South Texas Project
Units 3 and 4
Docket Nos. 52-012 and 52-013
Revised Response to Request for Additional Information

1. RAI 03.07.01-29, Supplement 2
2. RAI 03.07.02-32, Revision 1

RAI 03.07.01-29, Supplement 2**QUESTION:**

RAI 03.07.02-32, Revision 1**QUESTION:**

Figure 3.7-47: Control Building Annex North-South Input Motion for Stability Evaluations (7% Damping)

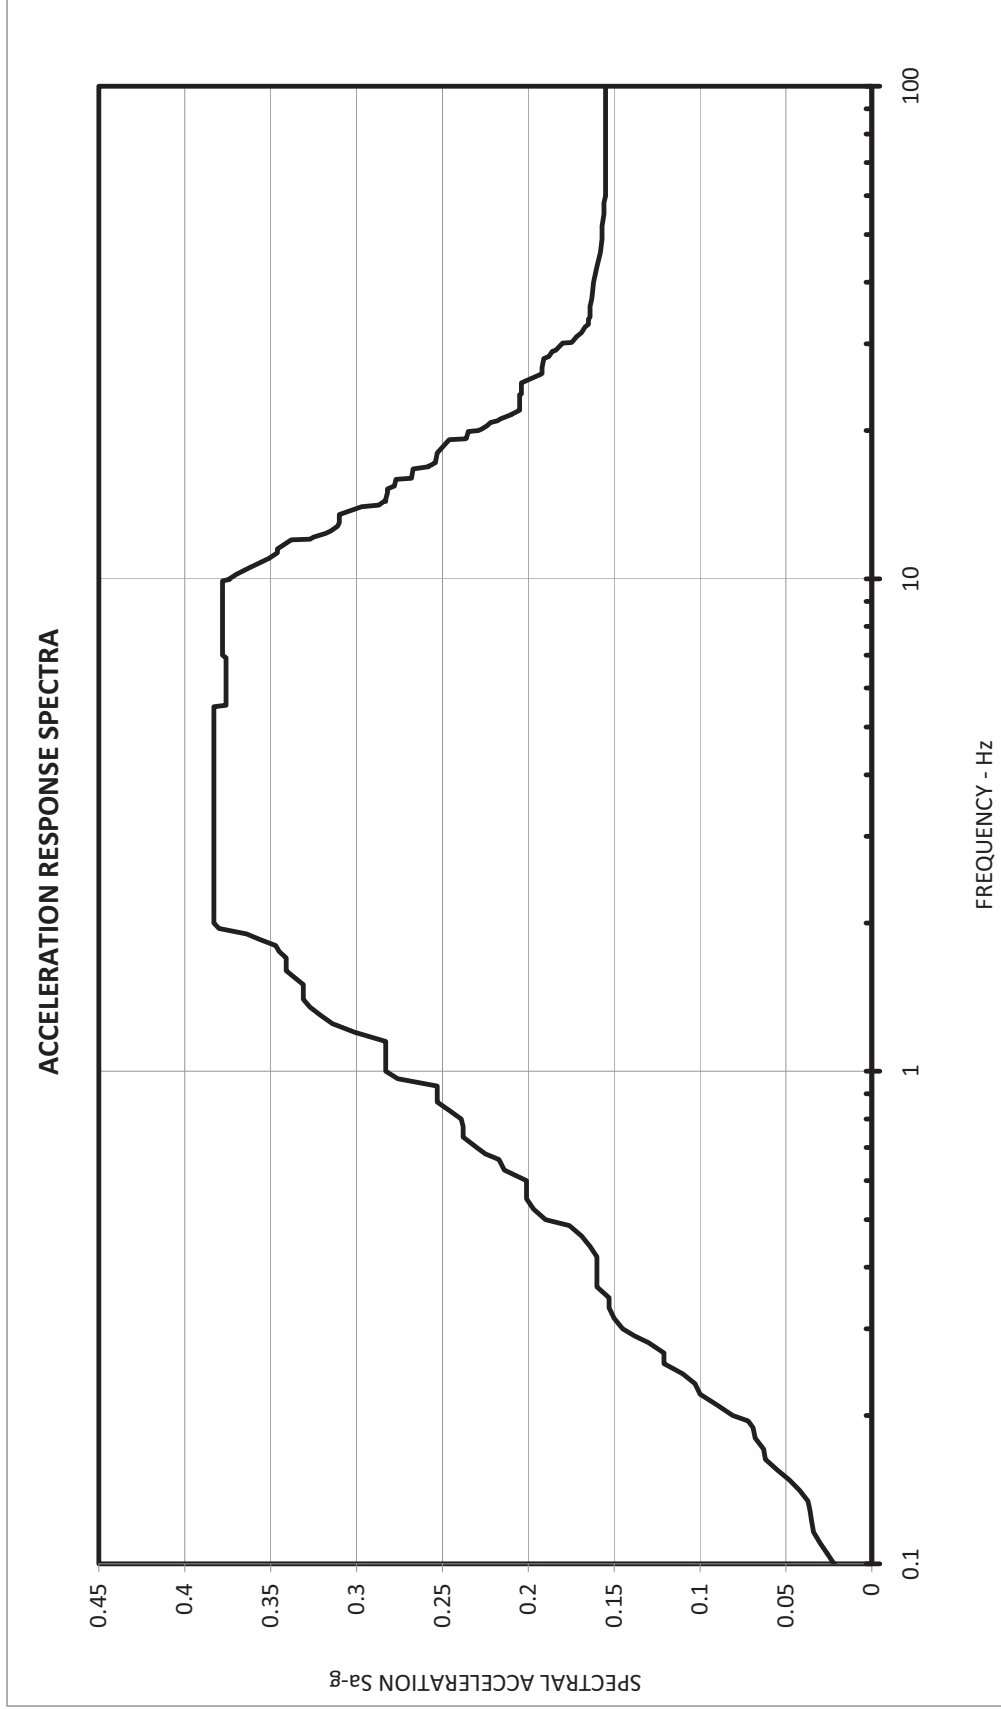
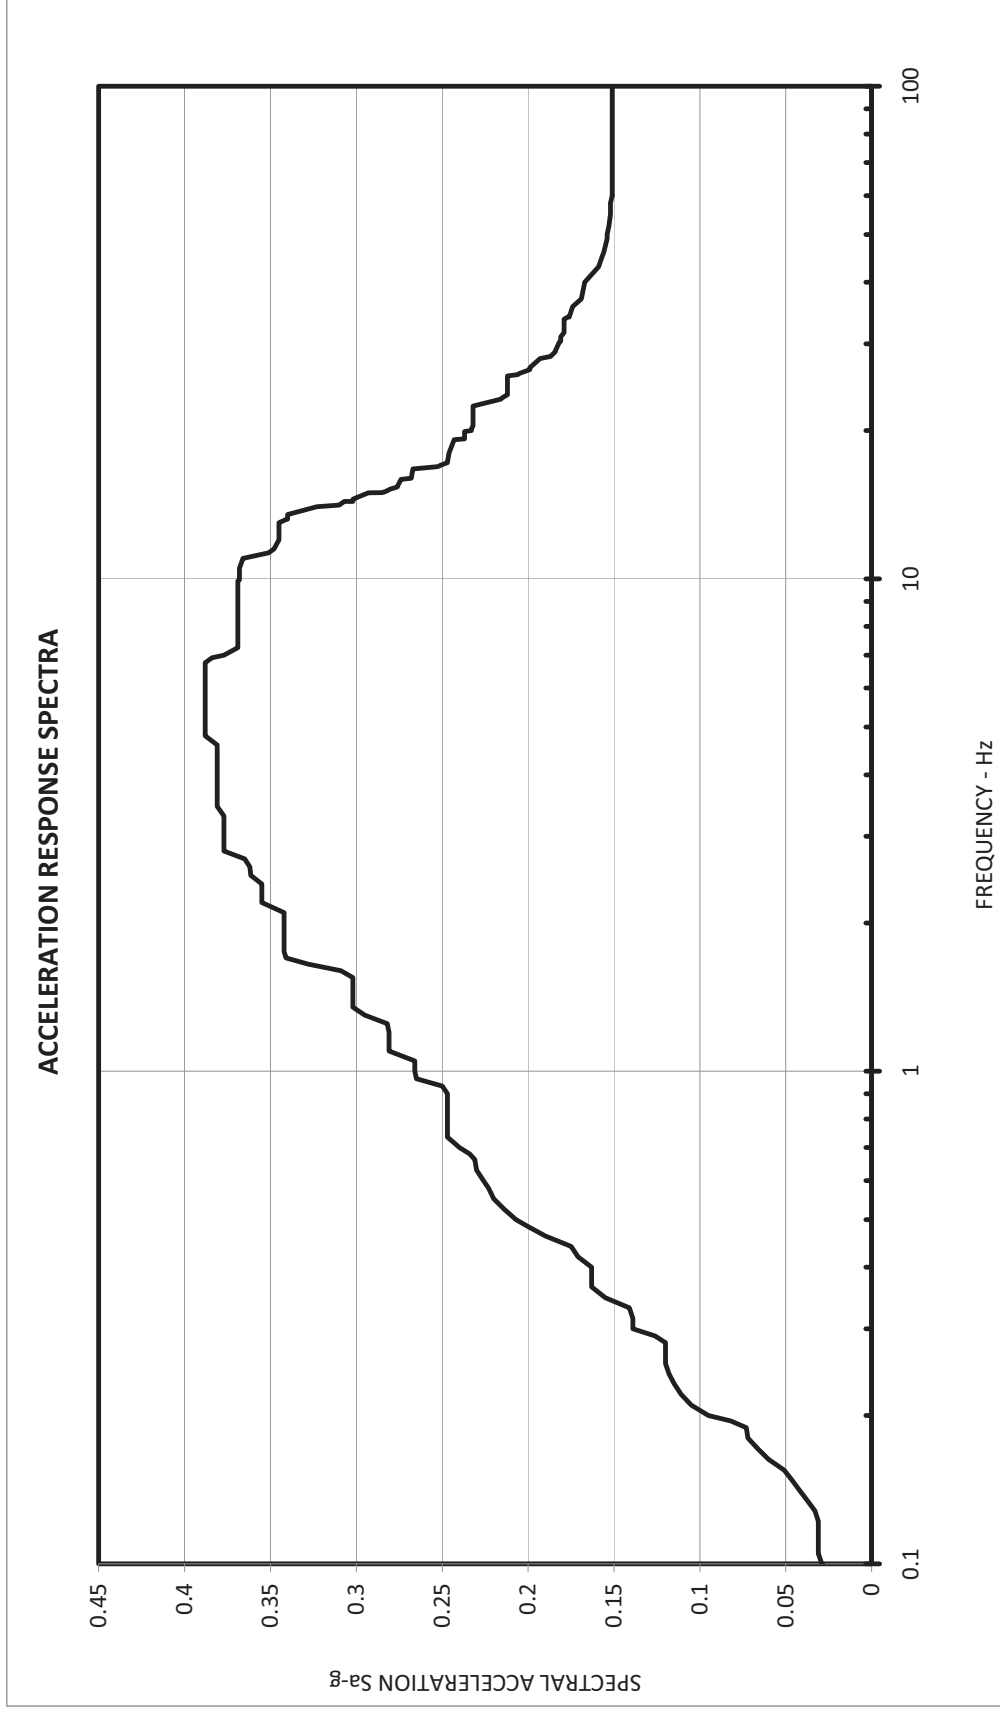
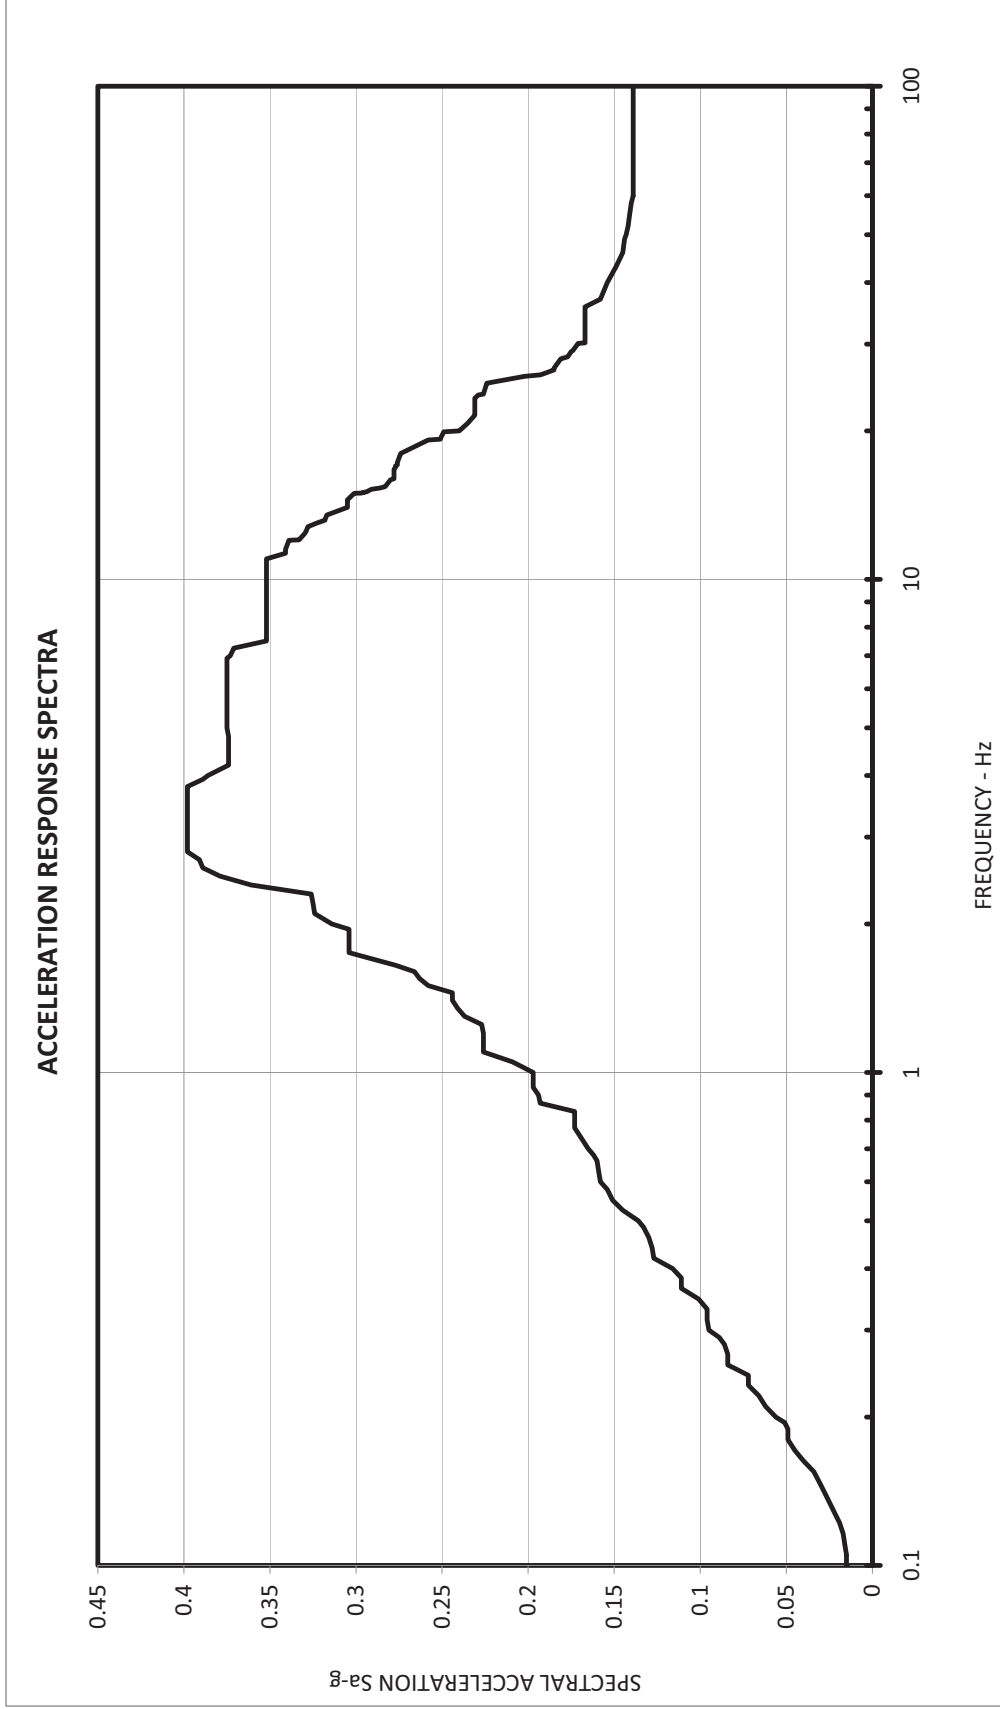
- Provide seismic input motions figures for II/I evaluation of all structures requiring seismic II/I evaluation.
 - In COLA Section 3.8, provide a pointer for Diesel Generator Fuel Oil Tunnels (DGFOT) details in Section 3H.7.

See revised COLA Section 3.7.3.16 and new COLA Figures 3.7-47 through 3.7-55 provided in the Enclosure.

For the stability evaluation of the CBA, the SSE input (see Figures 3.7-47 through 3.7-49) is the envelope of the average response of the five interaction nodes from the site-specific SSI analysis described above and the site specific SSE.
